RTI Errata

MARC4 4-bit Microcontrollers

Errata Sheet

Rev. 4814A-4BMCU-06/04

Figure 2. General Timing of the Reset Sequence

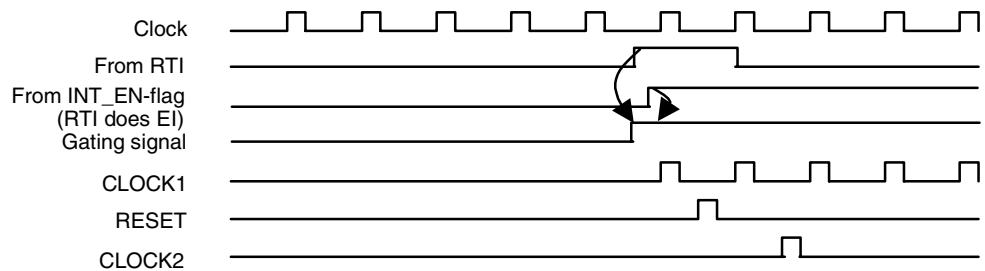
During the RTI, the RESET Enable block controls that the RESET only removes the just finished interrupt, i.e., the one with the highest priority, from the pending and the active register. The first CLOCK1 is redundant, the next CLOCK1 signal following the RESET transfers the modified information from the pending to the priority register. If more than 1 interrupt is pending, only the flag for the interrupt with the highest priority is set to “1” in the priority register. CLOCK2 updates the active register. If there is already an interrupt active, it has not been overwritten by the new priority. Only interrupts with a priority higher than the one just active are added to the active register. This allows the controller to return to the previous interrupt service routine when it has finished processing the interrupt with the higher priority.

Figure 3. Spike in the Reset Sequence

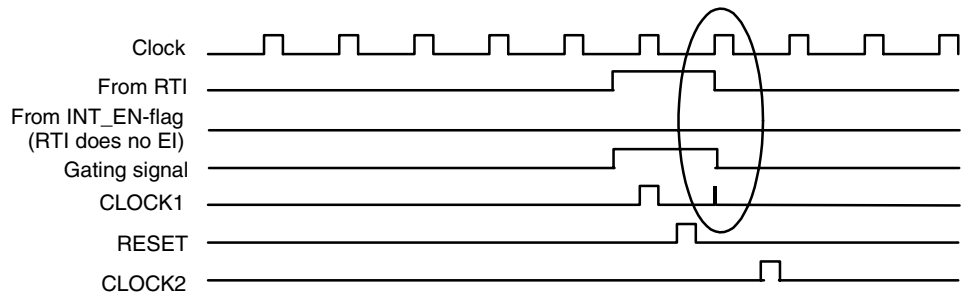
If an interrupt occurs at the same time as a DI-command, the internal timing of the following RTI is slightly changed. The result, visible in the application, additionally depends on the command following the DI (no effect if NOP follows DI, no more interrupts if a CALL follows DI). The behavior and the timing of the reset sequence do not change if the interrupt does not occur simultaneously with a DI command

The root cause is an unforeseen influence of DI, the command following DI and the RTI to the CLOCK1-gating signal. The duration of this decoded signal is shortened if the enable interrupt flag is reset (interrupt disabled). Depending on the command following the DI, the valid and necessary second CLOCK1 is reduced to a spike (NOP) or completely disappears (CALL, LIT_x...).

Figure 4. Status Before RTI

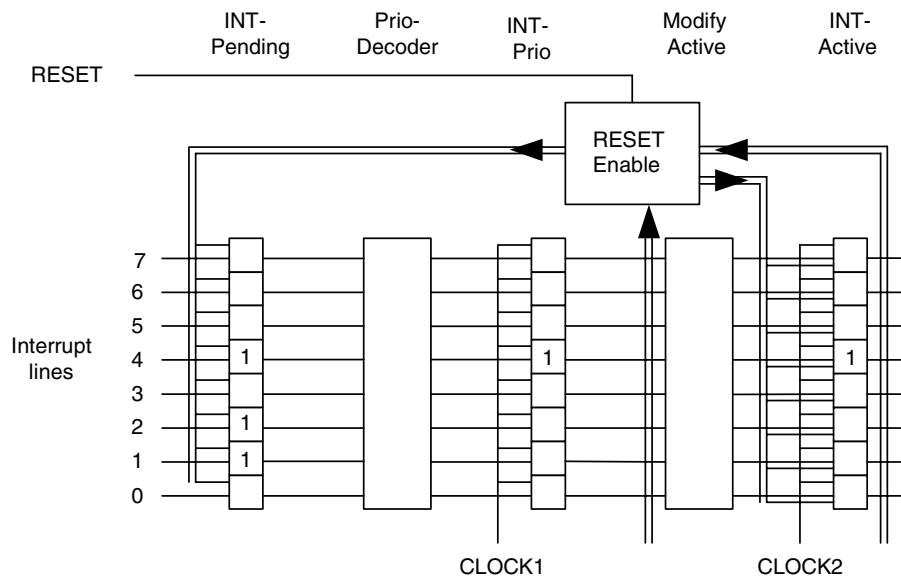
The effect of this behavior to the interrupt registers is the following. If an interrupt exactly meets a DI, it is nevertheless stored in the pending register, transferred to the priority register and then to the active register (Figure 4). It stays in the active register as long as the controller does not return from the corresponding interrupt service routine.

Figure 5. Status After RTI

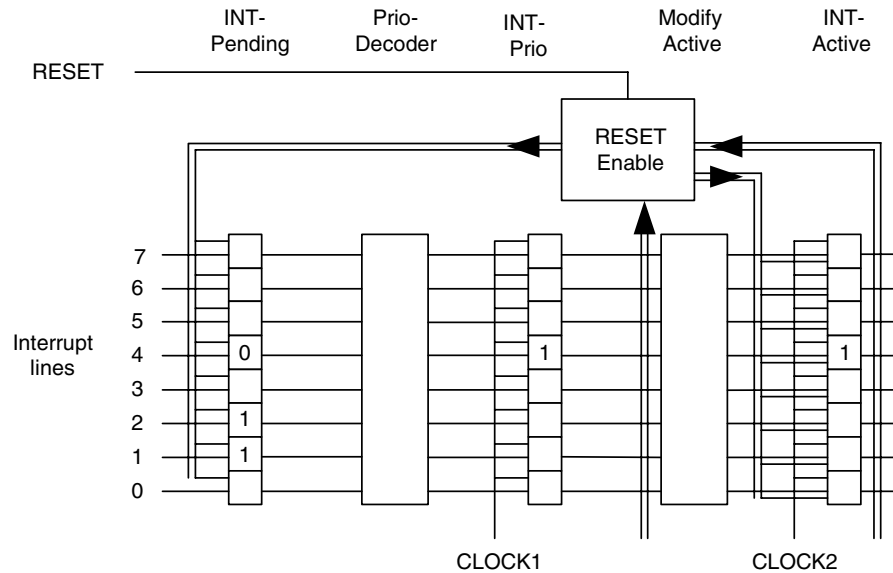
The above described modified reset sequence starts with the RTI. If the command following the DI is a CALL, the first CLOCK1 does not change anything, the RESET forces the relevant bits from pending and active register to zero, the next CLOCK1 signal is missing and leaves the priority register unchanged, the adjacent CLOCK2 takes over the information from the priority register again (Figure 5). As long as the active register is set, the controller cannot execute a new interrupt of the same or a lower priority.

Figure 6. Interrupt with Higher Priority Appears

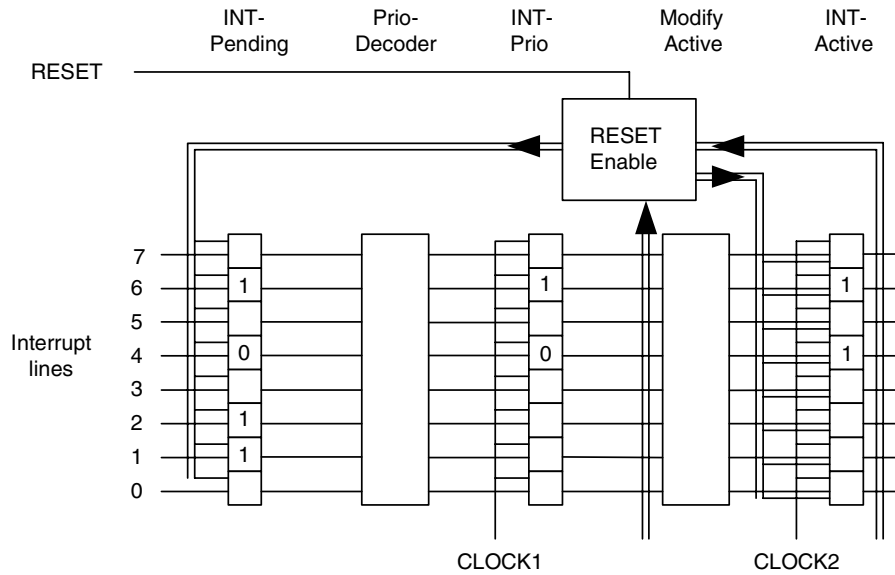
Even an interrupt with a higher priority, entering the pending register, does not finish this lock-up condition. This event leads to an update of the priority register. Only one interrupt, the one with the highest priority, is stored here. It does not delete the wrong contents from the active register but adds the higher priority interrupt to it. Deleting an interrupt from the active register is only possible if the corresponding bit of the priority register is set.

Figure 7. Interrupt with Higher Priority Finished

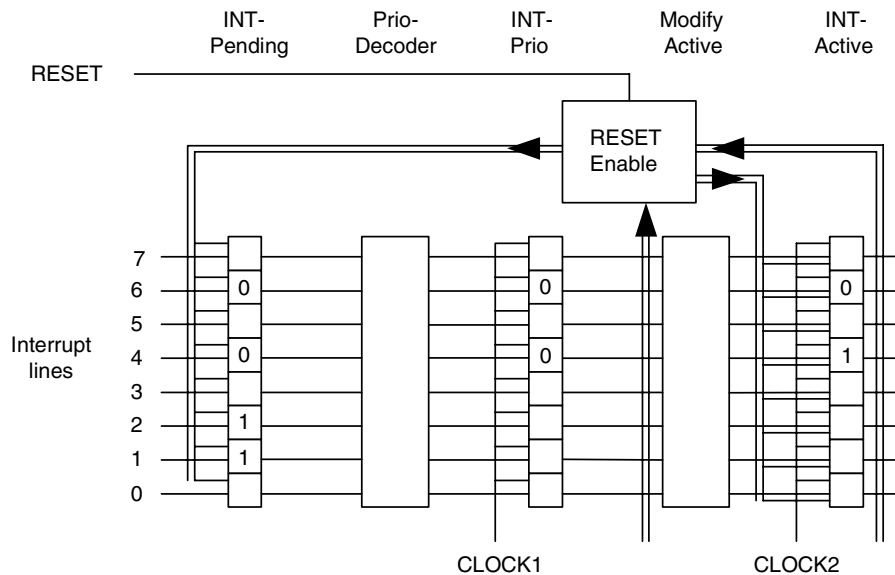
The RTI resets the bits of the active and the pending register that are marked in the priority register. This new content is evaluated and transferred to the priority register. Then, the higher interrupt will be finished, but the lower one will be still kept in the active register, continuously disabling interrupts of the same or lower priority.

Figure 8. Interrupted Interrupt

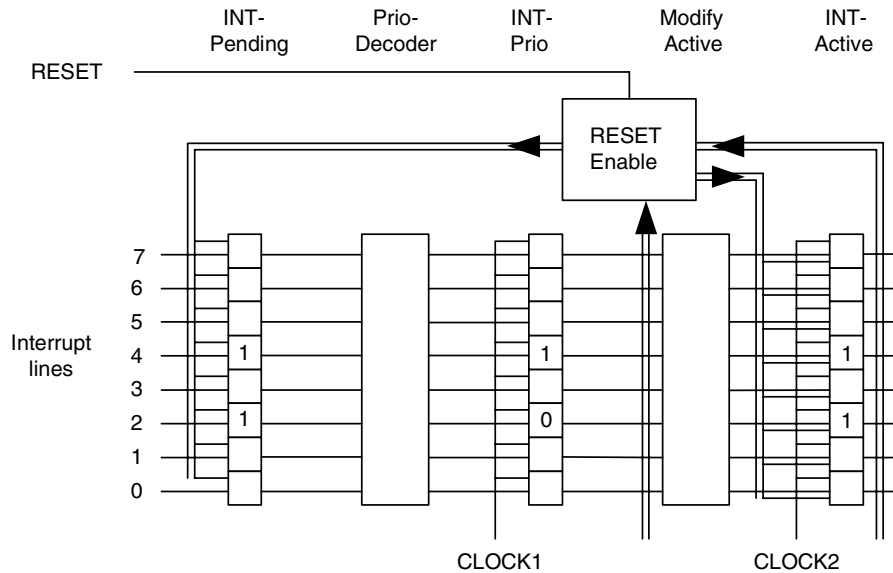
The following example describes a special condition: A first interrupt (for example INT2) has entered the pending register normally, is active and the service routine is just under execution. This routine contains a DI command. If a second interrupt (for example INT4) with a higher priority exactly meets this DI, the DI will be executed but the controller jumps to the service routine related to the higher interrupt. The register status at this moment is given in Figure 8.

Figure 9. After Return from INT4

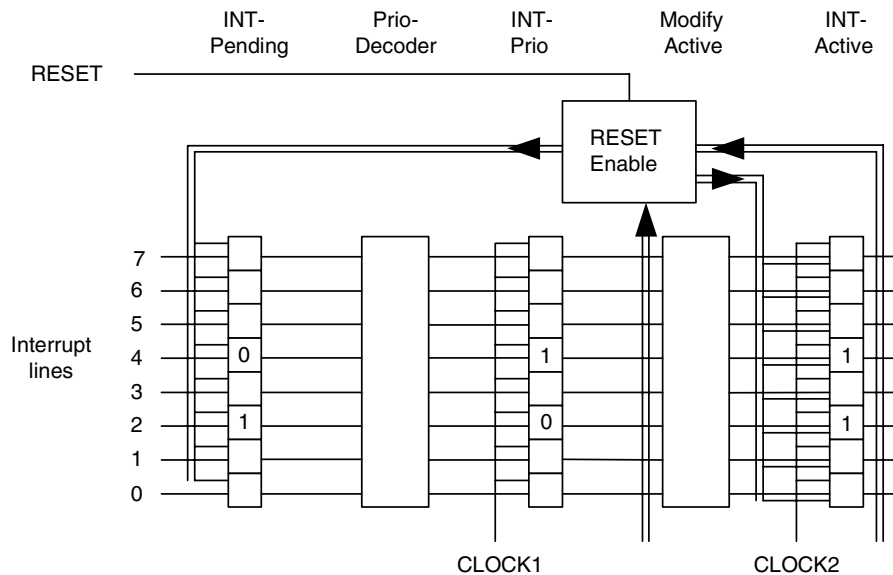
Finishing INT4 causes the program control to switch back to the INT2 service routine that was interrupted before. Due to the missing CLOCK1 after RESET, however, the priority and the active register stay unchanged after the reset sequence, while the INT4 flag in the pending register is deleted.

Figure 10. After Return from INT2

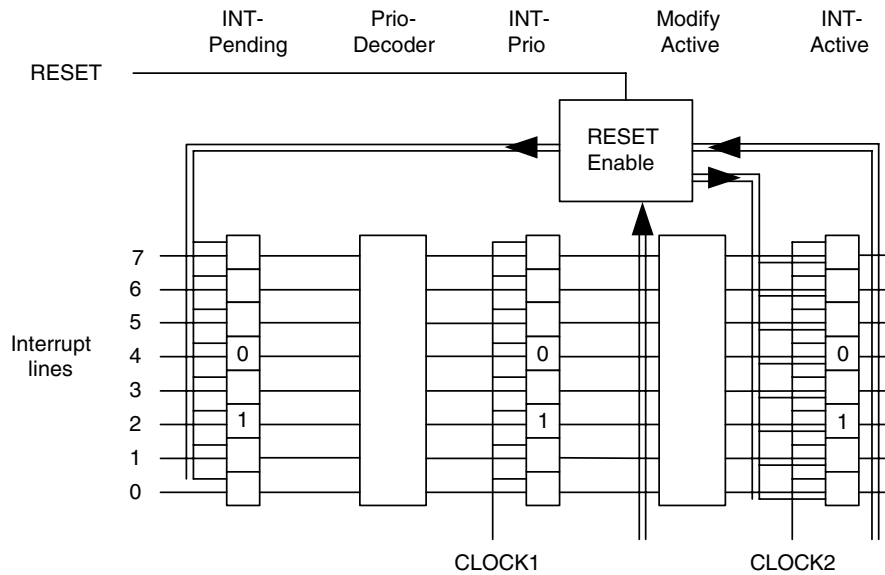
Then, the controller continues processing the INT2 service routine. Leaving this routine with the RTI activates once more the reset sequence. The highest interrupt, marked in priority and active register, is deleted from the pending and the active register with RESET. CLOCK1 and CLOCK2 update the priority and the active register as shown in Figure 10.

This time it is not the interrupt that met the DI (INT4), but the one that has already been active before (INT2) that blocks further interrupts of the same or lower priority.

Figure 11. Modified Timing

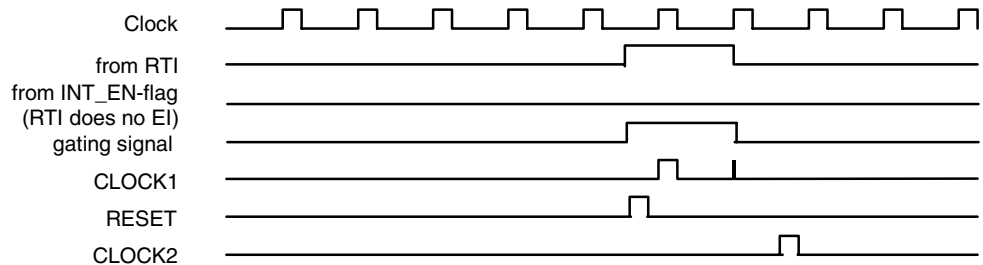
The described function is caused by an undetected influence to the timing of the interrupt controller's reset sequence. To solve this issue, Atmel will correct the timing. First, the MTP-parts ATAM893 and ATAM894 will incorporate this enhancement. The modification under test conditions is shown in Figure 11.

Moving the RESET in front of the first CLOCK1 solves the issue of the missing second CLOCK1. Now, the reset sequence starts with the RESET of the active and pending register, then CLOCK1 updates the priority register and CLOCK2 updates the active register. To ensure proper operation under all conditions, intensive simulations with different software configurations are ongoing. The hardware revisions of the corrected MTPs will be named ATAM893T and ATAM894R. They will be available in Q3/2004.
